BIRENBERG RESIDENCE 18 Quaker Meeting House Road, Armonk, NY 10504. PROPOSED POOL PLAN SP-1

To:	North Castle Engineering Kellard Sessions, Joseph Cermele, P.E.		
From:	Ahneman Kirby, LLC - Keith Werner		
Project:	Eric Birenberg 16 Quaker Meeting House Rd Armonk, NY 10504		
RE:	Eric Birenberg 16 Quaker Meeting House Rd Section 101.03, Block 4, Lot 44		
Subject:	Site Development Review Comments and Conditions of Approval	AKL Project No:	20-087-D083
Comment Date:	March 5, 2021	Response Date:	March 23, 2021

PREPARED FOR:
BIRENBERG RESIDENCE
18 Quaker Meeting House Road, Armonk, NY 10504
(Tax ID: 101.03-4-44)
PROPOSED POOL PLAN
SP-1

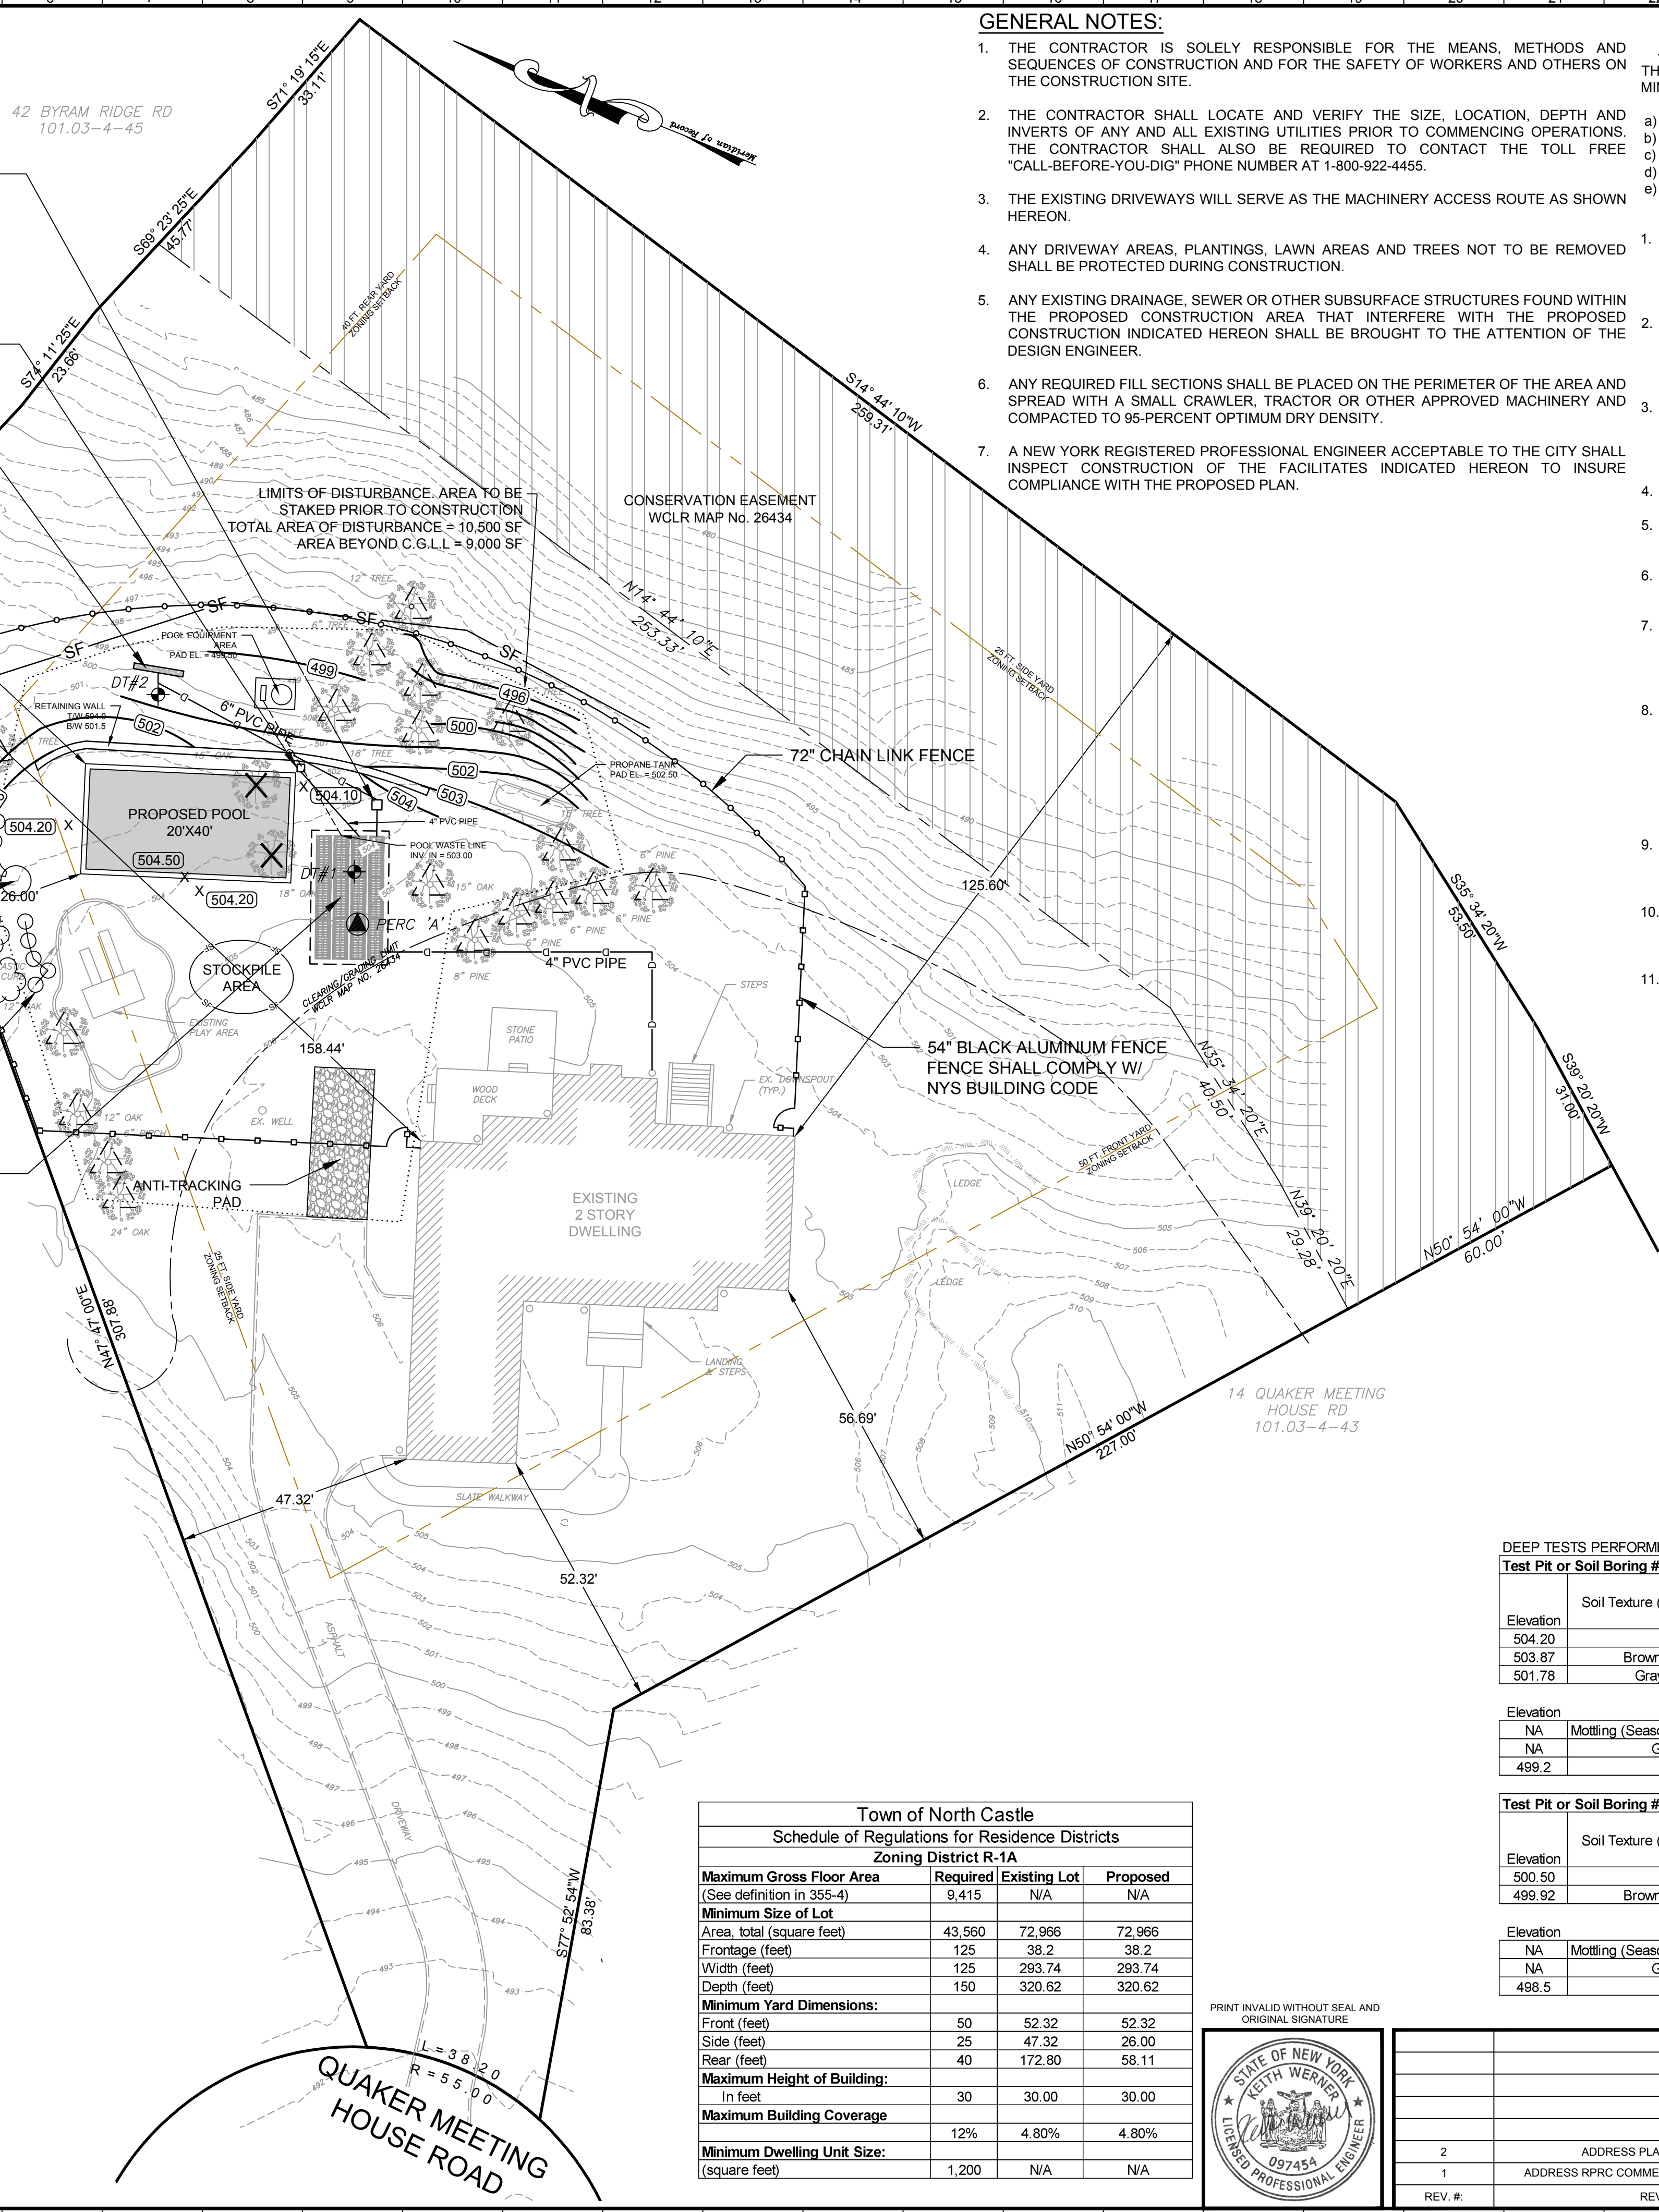
No.	Comment	Comment Section	Author	Response
1	The proposed pool improvements are located beyond the Clearing and Grading Limit Line (CGLL), as established by the Leisure Farm Subdivision Plat. An approval from the Planning Board will be required for the proposed expansion of the CGLL for the pool as proposed.	General Comments	Joseph Cermele, P.E.	Confirmed. We are awaiting planning board approval of the proposed pool.
2	The proposed retaining wall is required for the construction of the proposed pool. As such, it must respect the principal side yard setback. The plan should be revised to avoid this, or an area variance will be required.	General Comments	Joseph Cermele, P.E.	The retaining wall has been shown to stop at the required side yard setback.
3	The plan shall illustrate and quantify the limit of disturbance. Additionally, the plan shall illustrate and quantify the disturbance area beyond the approved Clearing and Grading Limit Line, as established by the Leisure Farm Subdivision Plat.	General Comments	Joseph Cermele, P.E.	The plan has been updated to illustrate and quantify the limits of disturbance. The plan has been updated to illustrate and quantify the limits of disturbance beyond the clearing and grading limit line.

4	Show the location of the existing septic primary area on the plan. The plan shall show this area to be cordoned off during construction. Additionally, the plan shall demonstrate that all required separation distances to the existing septic system and drilled well, per the Westchester County Department of Health (WCHD), have been maintained to the proposed infiltration system and pool.	General Comments	Joseph Cermele, P.E.	The subject property is currently and will continue to be on sewer service.
5	The elevations noted on the deep test results shall coordinate with the existing survey elevations. The test result summary shall be revised accordingly.	General Comments	Joseph Cermele, P.E.	The deep test elevations have been updated to match the survey elevations.
6	It appears the proposed infiltration system does not meet the required three (3) foot separation between the record elevation of ledge and bottom of the infiltration practice, as per Chapter 6 Section 6.3 of the NYSDEC Stormwater Management Design Manual. The system layout shall be revised accordingly.	General Comments	Joseph Cermele, P.E.	The Cultec system layout has been revised to provide for separation between the bottom of the system and ledge surface.

No.	Comment	Comment Section	Author	Response
7	As per Town policy and the RPRC determination letter, dated February 9th, 2021, the six (6) inch pool drawdown volume, without benefit of percolation, was found to be greater than the runoff volume generated by the net impervious increase from the 25-year, 24-hour design storm. The proposed infiltration system shall be revised to accommodate the six (6) inch pool drawdown volumetric storage capacity. The stormwater calculations shall be revised accordingly.	General Comments	Joseph Cermele, P.E.	The drainage system has been updated to accommodate the volume for the 6 inch pool drawdown. The calculations have been updated.
8	It appears the proposed grading will allow upland gradient runoff to discharge into the proposed pool. The applicant should consider revising the plan accordingly to divert the upland runoff around the proposed pool. Provide details.	General Comments	Joseph Cermele, P.E.	The plan has been updated to show spot elevations of pool coping. 3-4" above surrounding ground.

9	The plan shall include a pool fence and gate detail. The plan shall illustrate the proposed location of the pool fence. The plan shall note that the pool fence and gate shall comply with all applicable NYS Building Code requirements.	General Comments	Joseph Cermele, P.E.	A pool fence and gate detail has been included on the plan.
10	The plan shall clarify whether or not the proposed trench drain located on the east portion of the proposed pool is required. It is unclear how stormwater runoff generated from the proposed pool development will be collected into the proposed trench drain. If required, the plan shall illustrate a detail for the proposed trench drain.	General Comments	Joseph Cermele, P.E.	The trench drain has been eliminated and a yard drain has been added to collect surface water coming towards the pool development.
11	As shown on the plan, the pool equipment is located downgradient from the proposed infiltration system. The plan shall illustrate the connection between the pool equipment and drawdown mitigation practice and clarify how the proposed pool will be drawn down for winterization.	General Comments	Joseph Cermele, P.E.	The plan has been updated to show the pool equipment connected to the drainage system.

No.	Comment	Comment Section	Author	Response
12	As shown on the plan, it appears additional tree removal will be required based on the proposed locations of the proposed infiltration system, propane tank, and grading downgradient from the propane tank. The applicant shall consider which trees will require removal based on the proposed site improvements. All trees eight (8) inches dbh or greater located within and ten (10) feet beyond the proposed limit of disturbance shall be indicated to be removed and/or protected.	General Comments	Joseph Cermele, P.E.	All trees have been indicated to be removed and/or protected. Grading will take place to not disturb existing trees
13	The plan shall include a typical section of the proposed pool.	General Comments	Joseph Cermele, P.E.	The trench drain has been eliminated and a yard drain has been added to collect surface water coming towards the pool development.

14	The plan shall note the construction sequencing for the proposed pool development.	General Comments	Joseph Cermele, P.E.	A construction staging sequence has been added to the plan.
15	The plan shall illustrate the proposed elevation of the pool coping.	General Comments	Joseph Cermele, P.E.	Spot elevations have been added for the proposed pool coping and surrounding area.
16	The plan shall include a detail for the proposed retaining wall.	General Comments	Joseph Cermele, P.E.	A retaining wall detail has been added.
